Subject: RE: Green Bay Packaging Arkansas Kraft Class 3N Landfill - Cell 6 Construction Quality Assurance

Subject: Green Bay Packaging Arkansas Kraft Class 3N Landfill - Cell 6 Construction Quality Assurance

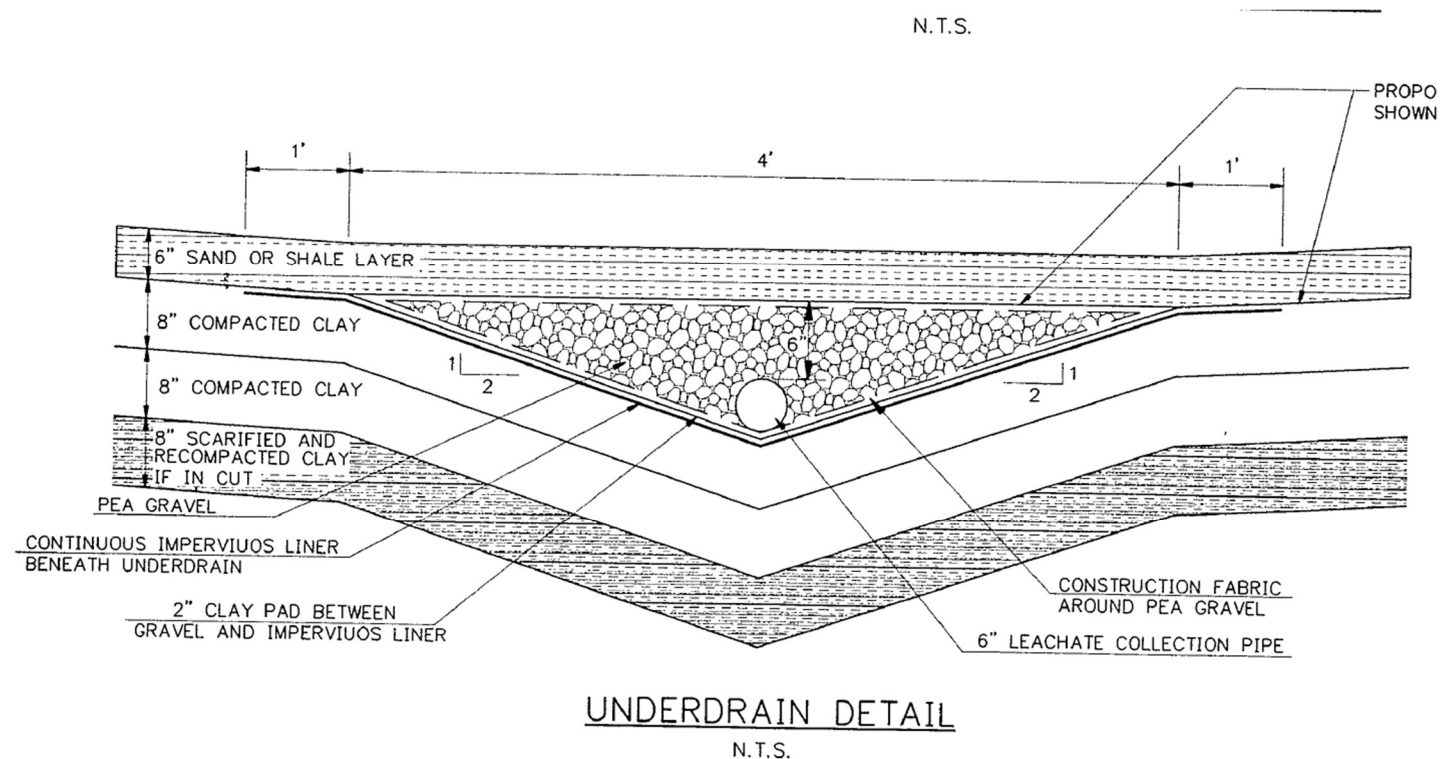
- 5) Geotextile failed the density (it is 9.06 oz/sy and it needs to be 10 oz/sy)
- The permit drawings (DIN #28317) page 8 of 13 (see screenshot below) call for a construction fabric around the leachate collection aggregate. The installer ordered a 10 oz/sy and the mass per unit area came back at a 9.06 which exceeds the requirement of the permit drawings. Therefore, the material was approved for use.

- 7) Doc ID 28317 Pdf page 3 of 13 seems to show they are shallow
- The permit drawings (DIN #28317) page 8 of 13 (see screenshot below) have a callout pointing to the top of clay liner that states "proposed bottom elevations shown on sheet 4". Comparing the as-built top of clay elevations to the permitted elevations on sheet 4 of 13, the as-built top of clay elevations appear to be at or above the permitted elevations.
